Project	IEEE 802.16 Broadband Wireless Access Working Group < http://ieee802.org/16 >	
Title	consolidation text in general	
Date Submitted	2006-05-09	
Source(s)	Jim Carlo, Wu Xuyong, Huawei Huawei Industrial Base, Bantian, Longgang, Shenzhen 518129 P.R.C	Voice: +86-755-28972324 Fax: +86-755-28975523 J.carlo@ieee.org ; wuxuyong@huawei.com
Re:	80216h-06_011: Working Group Review: P802.16h Working Document (2006-04-07)	
Abstract	Some consolidation text in General description for the working document	
Purpose	To introduce the basic component and basic relationship at the front of the WD.	
Notice	This document has been prepared to assist IEEE 802.16. It is offered as a basis for discussion and is not binding on the contributing individual(s) or organization(s). The material in this document is subject to change in form and content after further study. The contributor(s) reserve(s) the right to add, amend or withdraw material contained herein.

consolidation text in general
Huawei Technologies Co., Ltd.

figure hxx. neighbor relationship formed by bidirectional interference

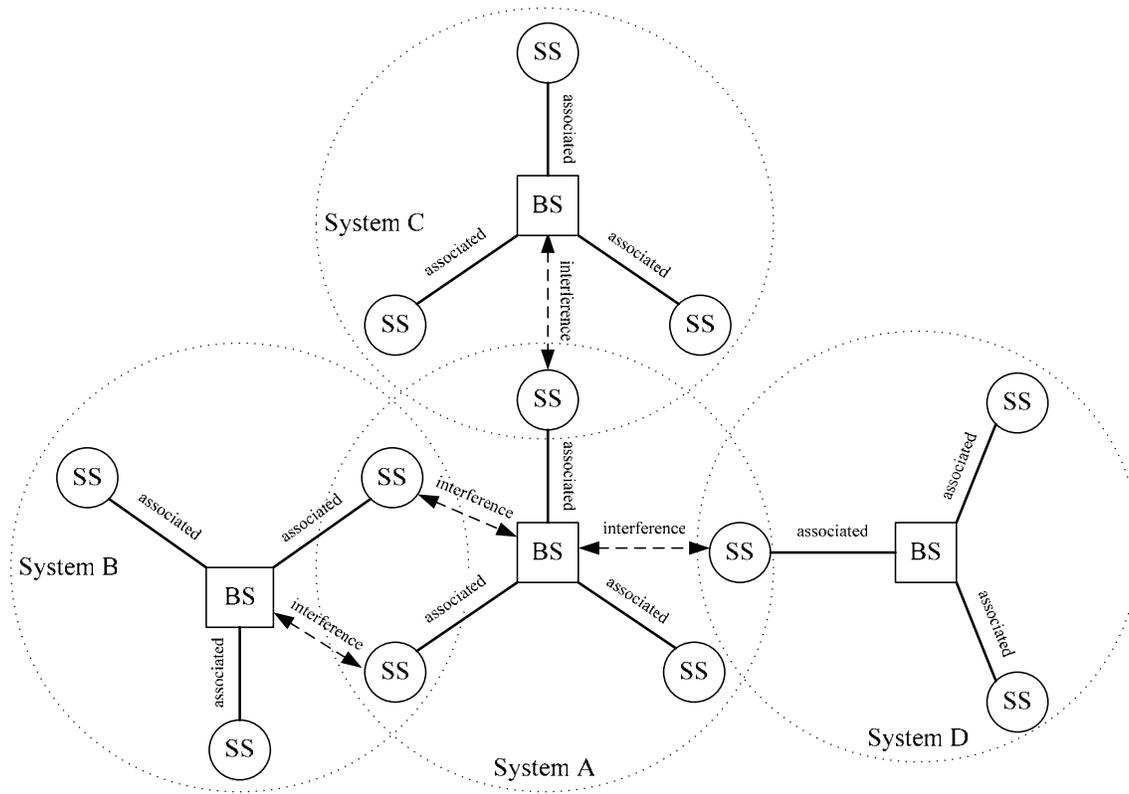
The figure hxx shows some examples of neighbor relationship formed by bidirectional interference. In the figure hxx, system A have neighbor relationship with system B, system C and system D, vice versa, system B have neighbor relationship with system A, so do system C and system D.

figure hxx. neighbor relationship formed by unidirectional interference

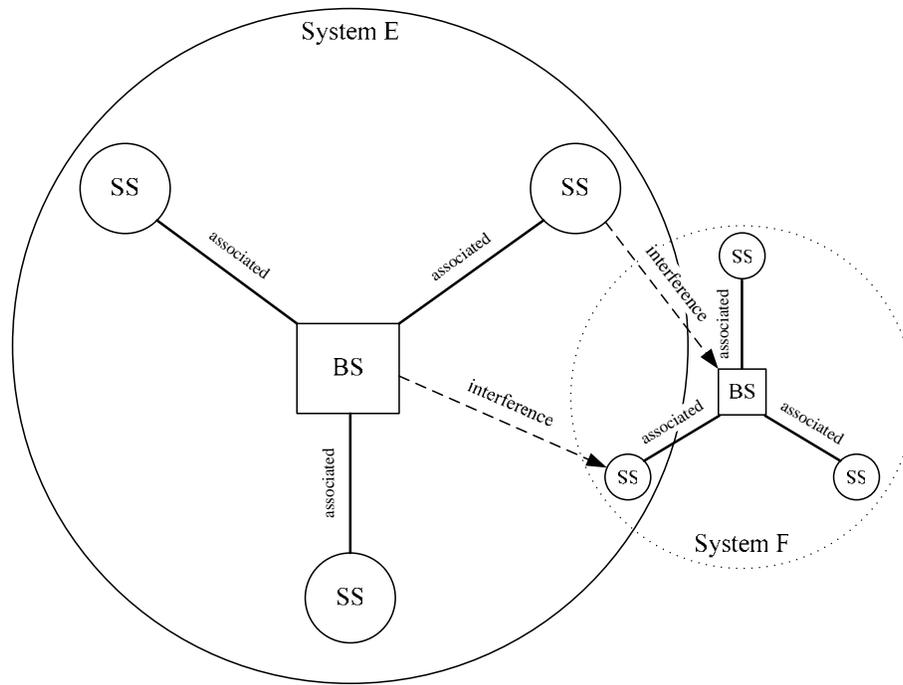
The figure hxx is an example of neighbor relationship formed by unidirectional interference., system E and system F have neighbor relationship with each other, although all the interference between the two systems is caused by system E. The interference from the SSs in one system to the SSs in another system, and from the BS in one system to the BS in another system is ignored, for the reason that they have been avoid by transmit/receive synchronization.

figure hxx. concept of neighborhood

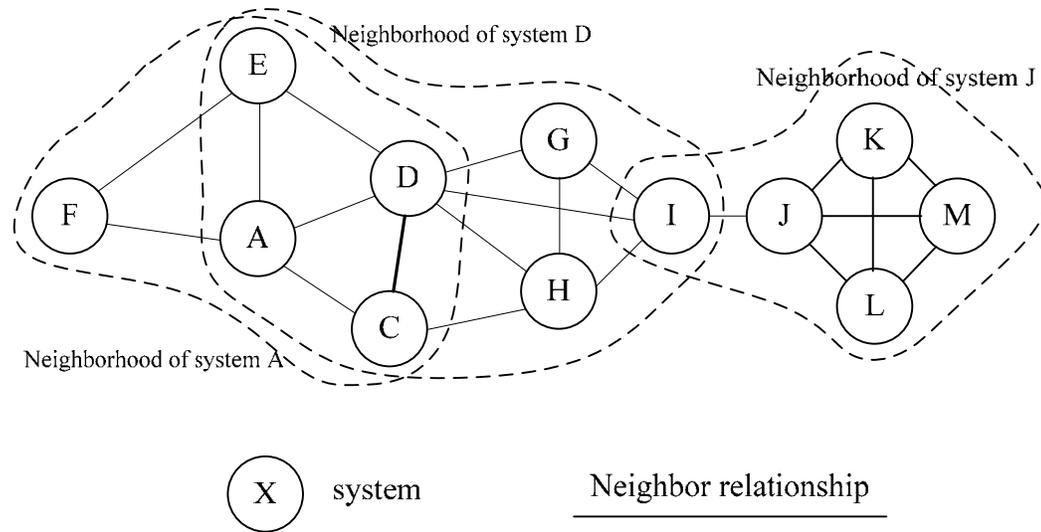
Interference Neighborhood: Interference neighborhood is relative to a system. A system will perceive as interference neighbors, all other systems which create/receive interference to/from it. The figure hxx shows some examples of neighborhood.
